### RESPONSE TO QUESTIONS

FCC ID: IHDT56BJ2  
Applicant: Motorola Inc  
Correspondence Reference Number: 4092  
731 Confirmation Number: TC635267  
Date of Original Email: 05/07/2002

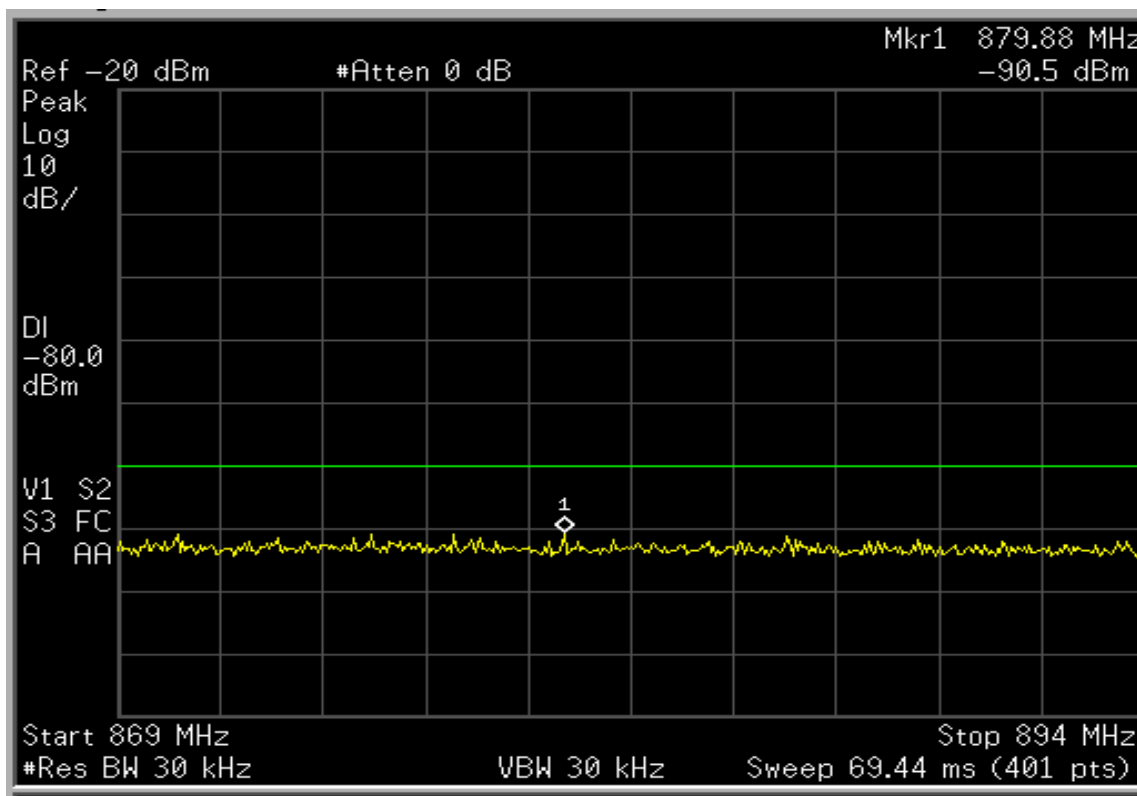
2) Measurement data showing compliance with 22.917(f) while in the 800 MHz CDMA mode.

**RESPONSE:** Refer to the following plot.
